Addendum 3

Client: Creswell School District
Project: CHS Academic Building Improvements (Primary) Project
Date: March 11, 2026
To: Interested Bidder
Prepared by: Curt Wilson, AIA; Principal, Wilson Architecture

This Addendum modifies the Project Manual, Specifications, and Drawings as follows:

1 DEMO ROOF PLAN - AREA A
D1.20 1/8" = 1'-0"

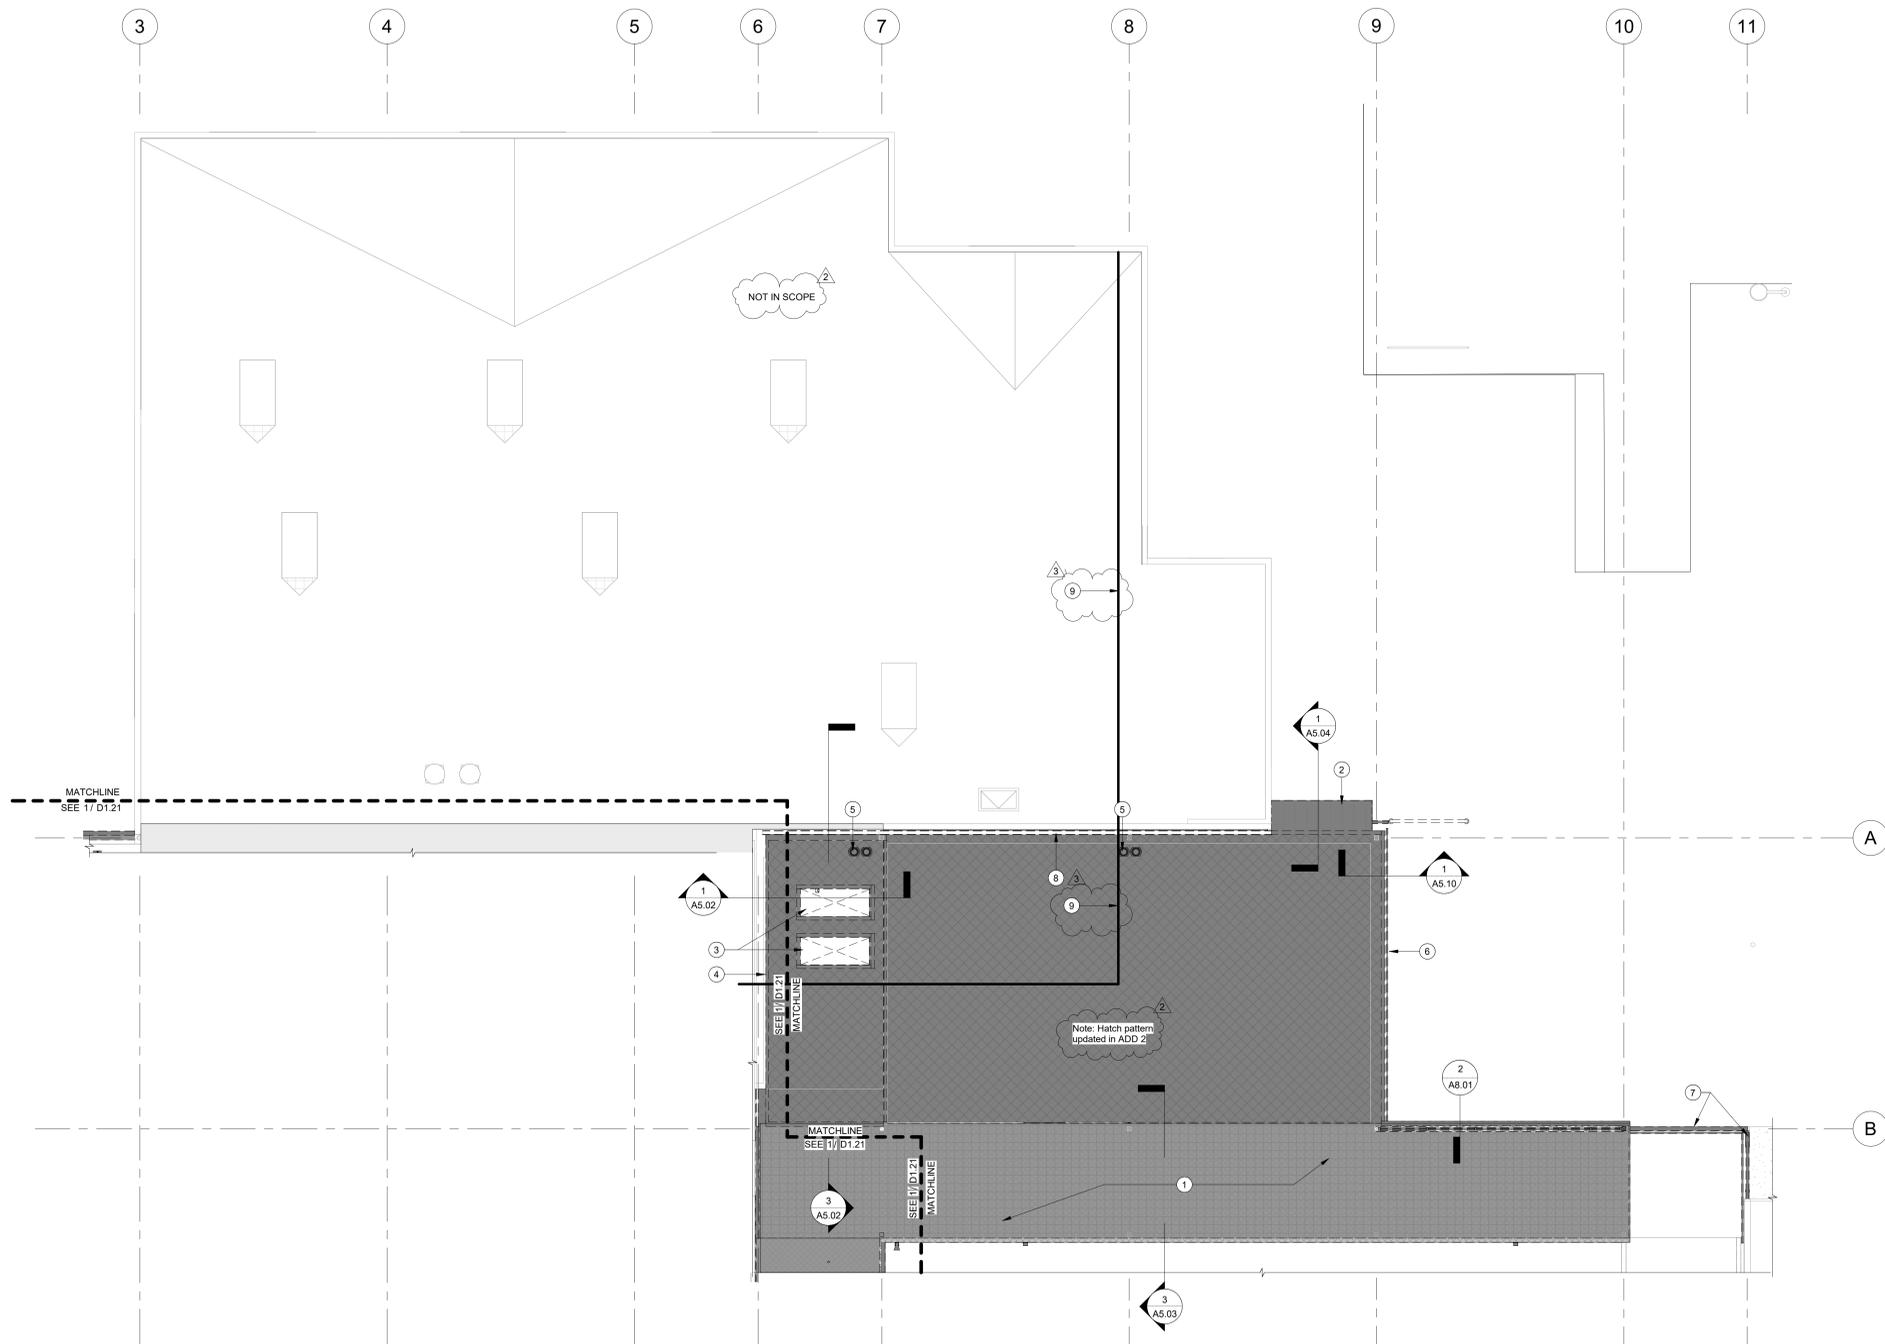
- 3.1. Sheet D1.20 – Demo Roof Plan – Area A
- a. Replace original sheet with attached version. A brief summary of the changes include:
 - Notes about existing conduit added to the drawing.

1 DEMO ROOF PLAN - AREA B
D1.21 1/8" = 1'-0"

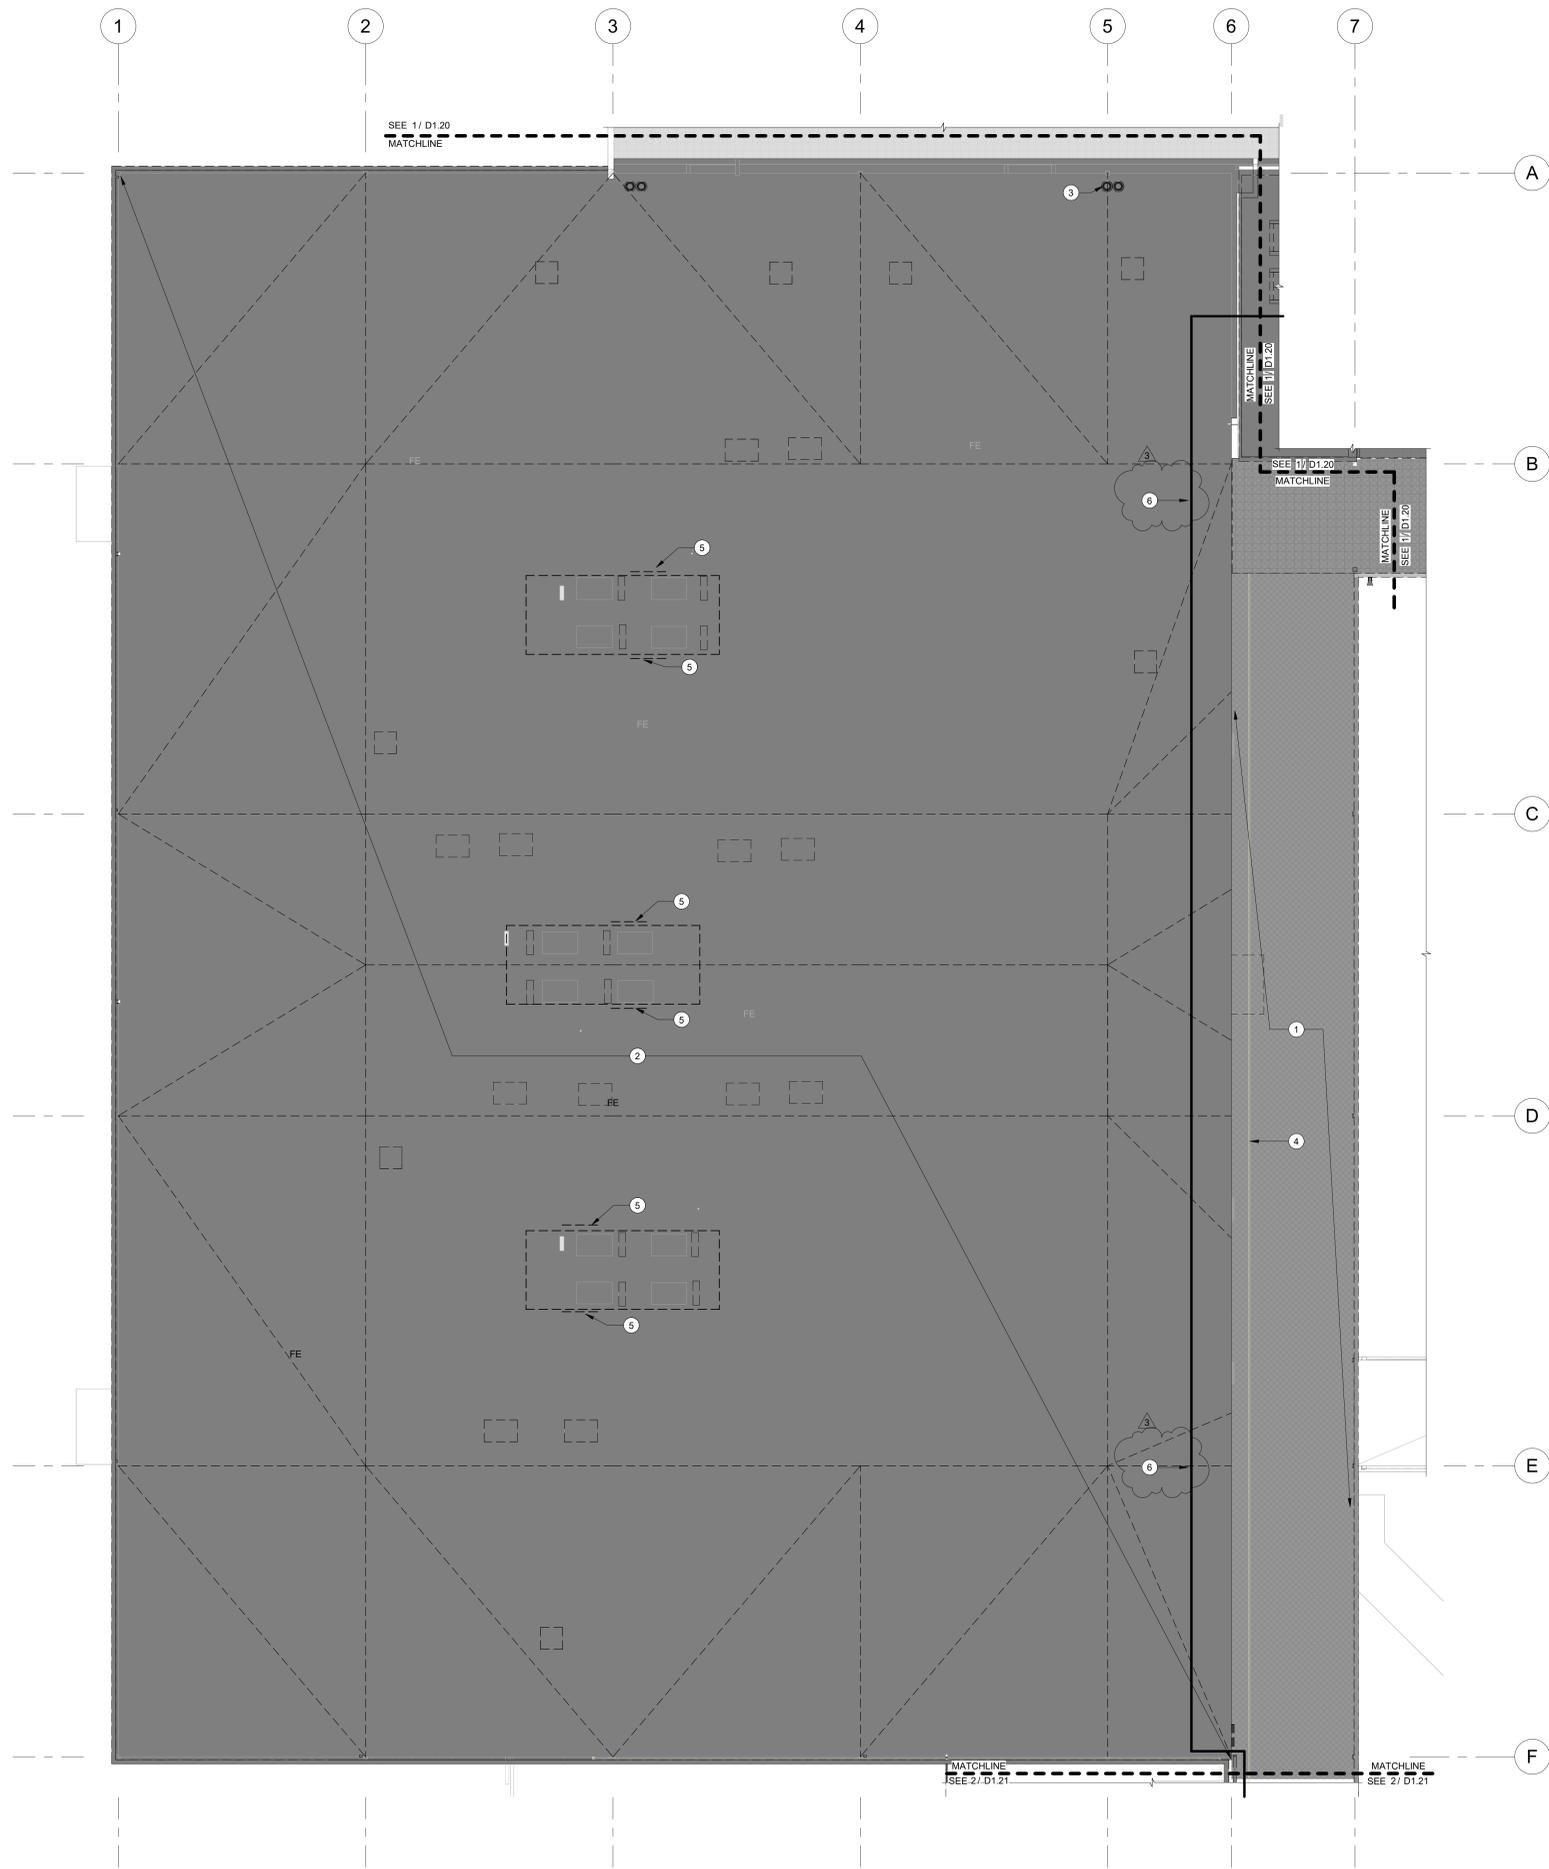
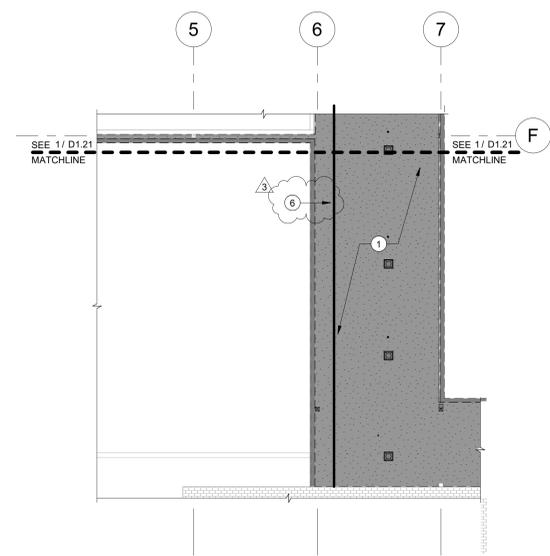
- 3.2. Sheet D1.21 - Demo Roof Plan – Area B and C
- a. Replace original sheet with attached version. A brief summary of the changes include:

- Notes about existing conduit added to the drawing.
- 3.3. Sheet A0.20 – Door and Window Schedule
- a. Replace original sheet with attached version. A brief summary of the changes include:

1 FLOOR PLAN - AREA B
 A1.11 1/8" = 1'-0"

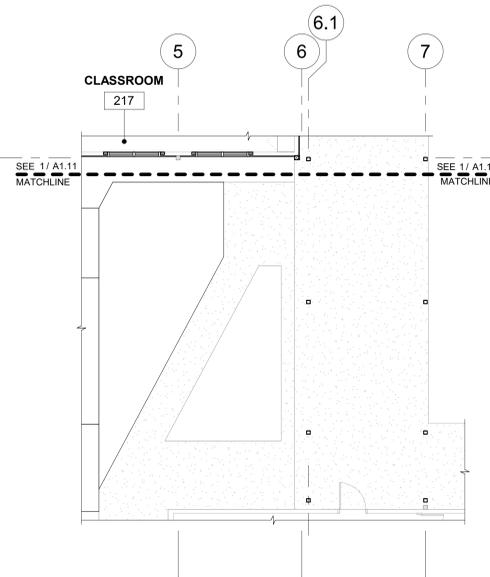
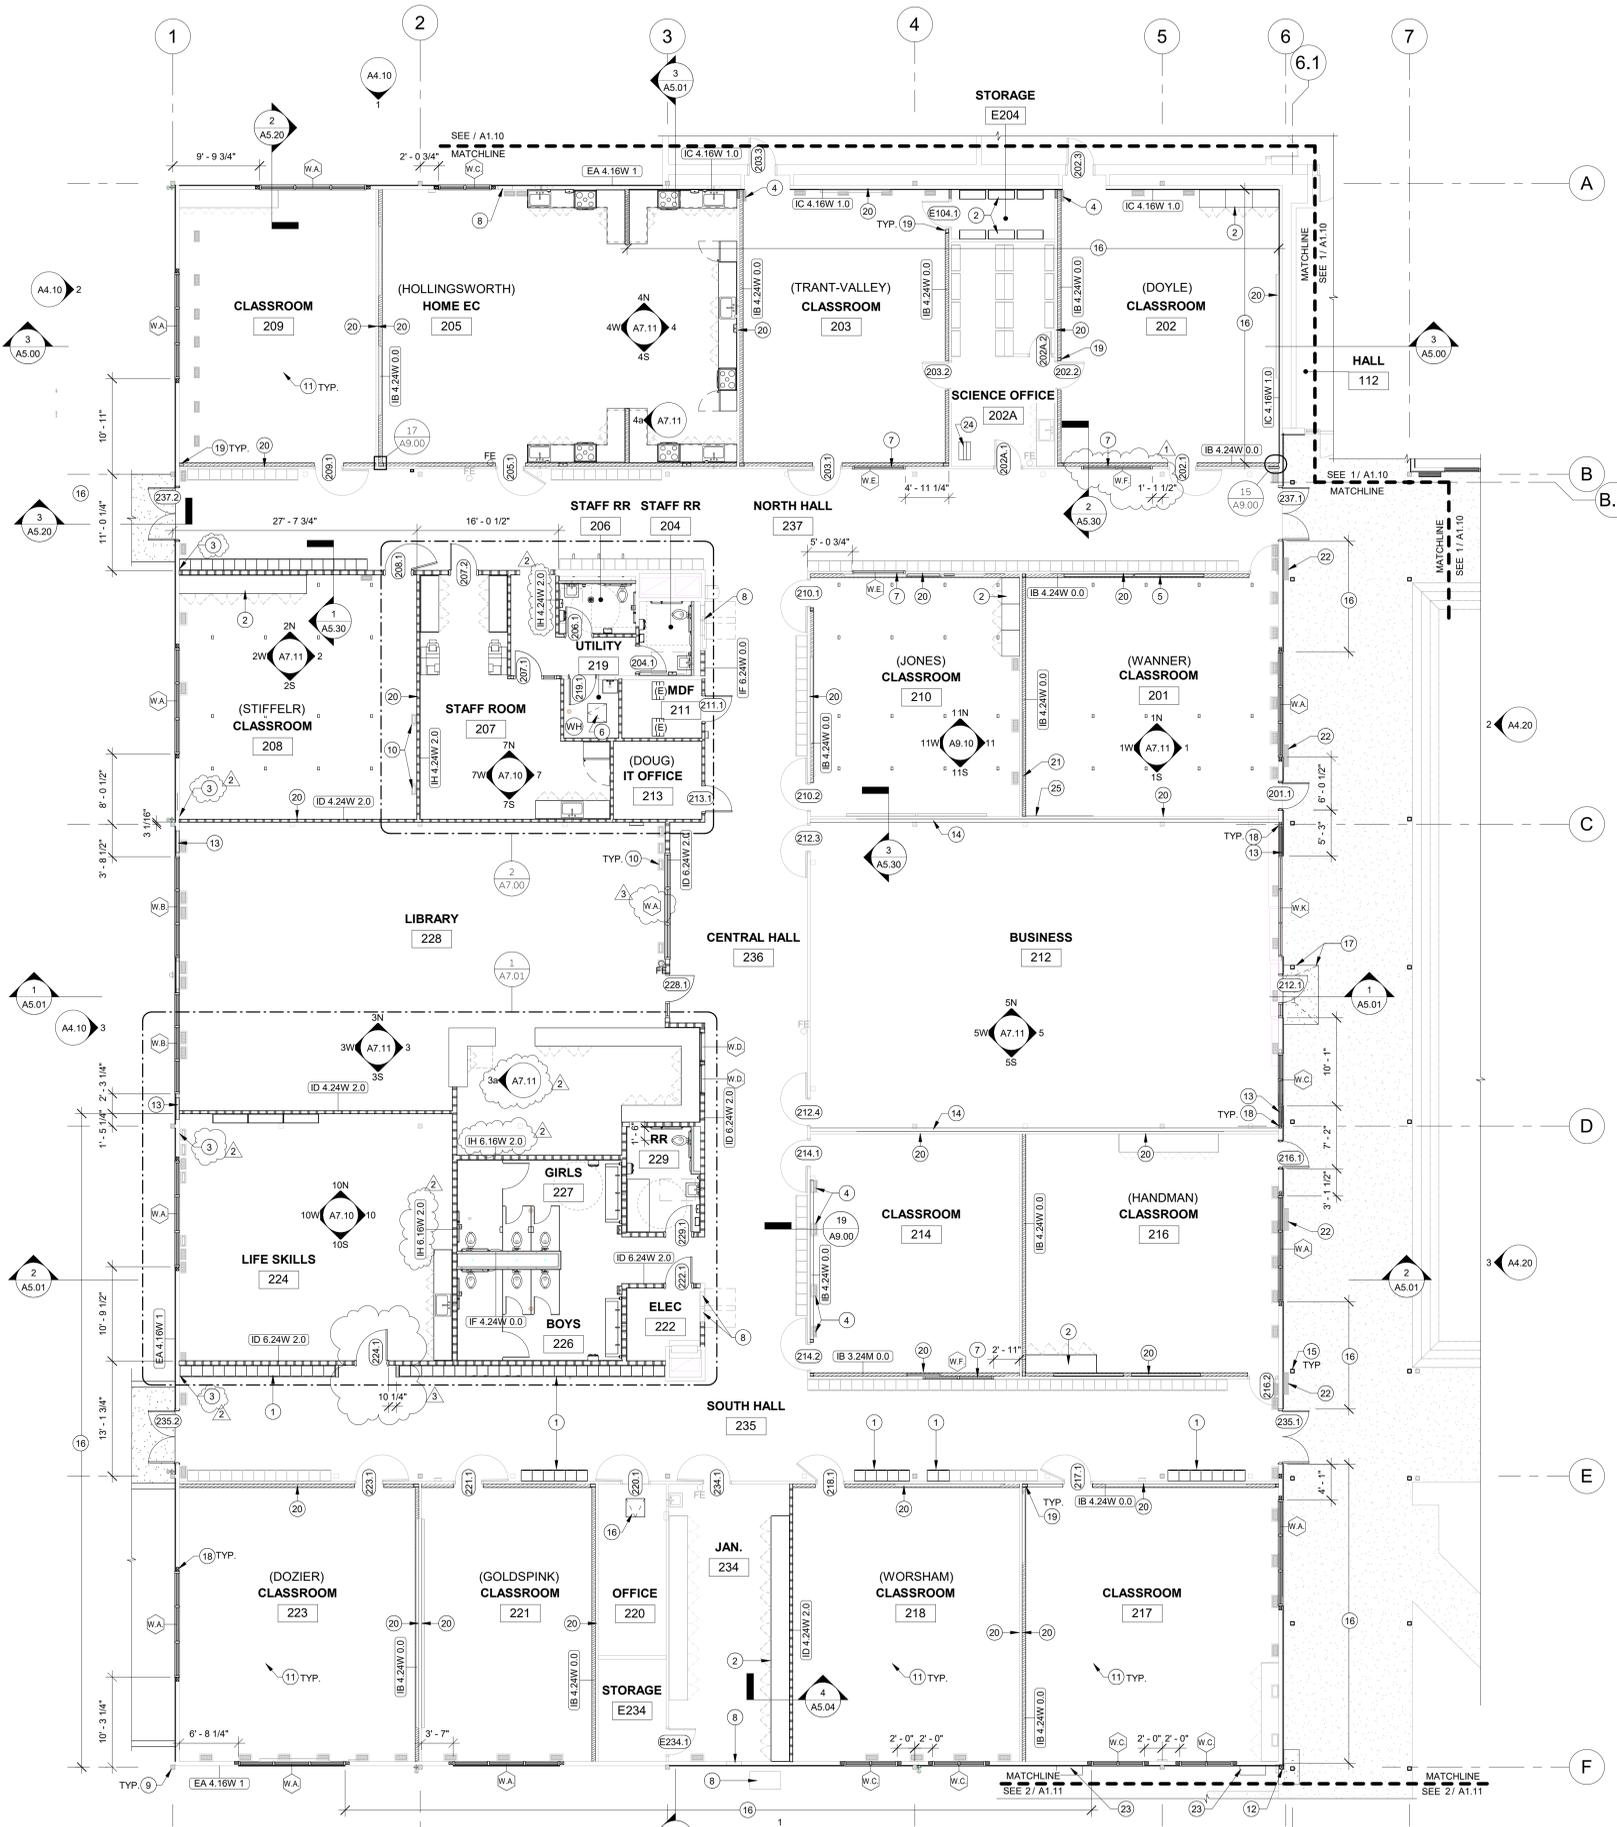
- 3.4. Sheet A1.11 – Floor Plan – Area B and C
- a. Replace original sheet with attached version. A brief summary of the changes include:
- Window type for windows in Library clarified.

- Size of door in Room 224 adjusted to 42 inches wide. Note, door number changed to 224.1.
- 3.5. Sheet A1.21 – Roof Plan – Area A
- a. Replace original sheet with attached version. A brief summary of the changes include:
